# 5 SUB-001634-2021

#### 500 C ST. FRANCIS STREET SUBDIVISION

# **DETAIL SITE PLAN**

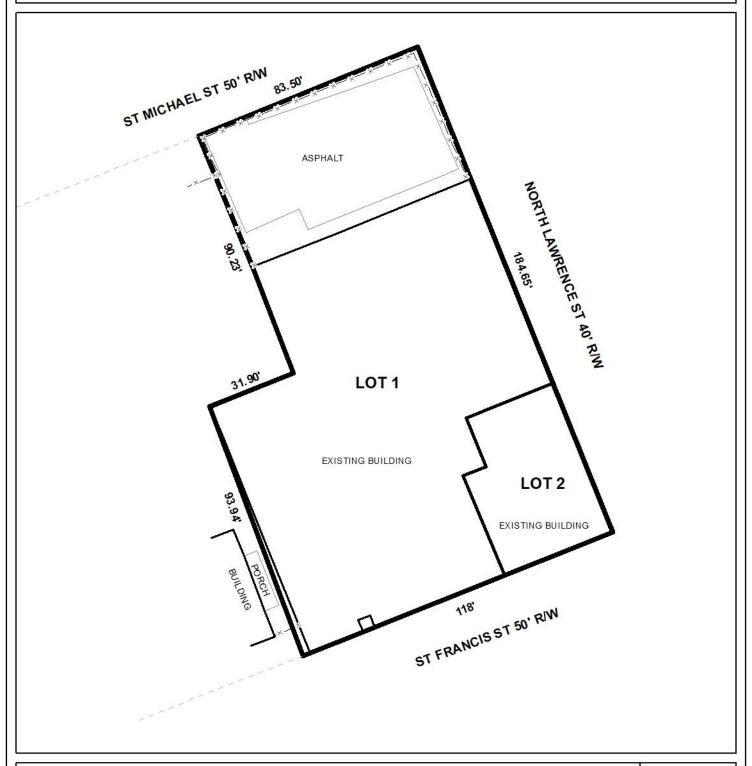
The proposed subdivision fronts St. Francis Street, North Lawrence Street, and St. Michael Street, and are each minor streets with curb and gutter. A 50' right-of-way is illustrated along St. Francis Street and St. Michael Street, each of which is adequate; however, a 40' right-of-way is illustrated along North Lawrence Street. It appears there is currently a 50' right-of-way at this location. No dedications were required along North Lawrence Street for any recent subdivisions in the area, thus a waiver of Section V.B.14. of the Subdivision Regulations may be appropriate; however, accurate right-of-way should be depicted on the Final Plat, if approved.

There are no building setback lines illustrated on the preliminary plat. Section 64-3.I.8.(d) of the DDD regulating plan allows a 0' minimum and 12' maximum setback along all street frontages in a T-5.1 sub-district. As such, if approved, revision of the plat should be required to depict the 12' maximum building setback line along all street frontages, and a note should be provided stating a 0' minimum building setback is allowed.

Lot 1 meets the minimum size requirements of Section V.D.2. of the Subdivision Regulations for lots served by public water and sanitary sewer systems, but Lot 2 does not. The Planning Commission has waived the requirements of Section V.D.2. for similarly sized lots within the DDD given the history of substandard subdivisions within downtown, thus a waiver of V.D.2. may also be appropriate for the proposed Lot 2.

- 1) Revision of the plat to illustrate the correct right-of-way along North Lawrence Street;
- 2) Revision of the plat to depict the 12' maximum building setback line alone all street frontages and provision of a note stating a 0' minimum building setback is allowed;
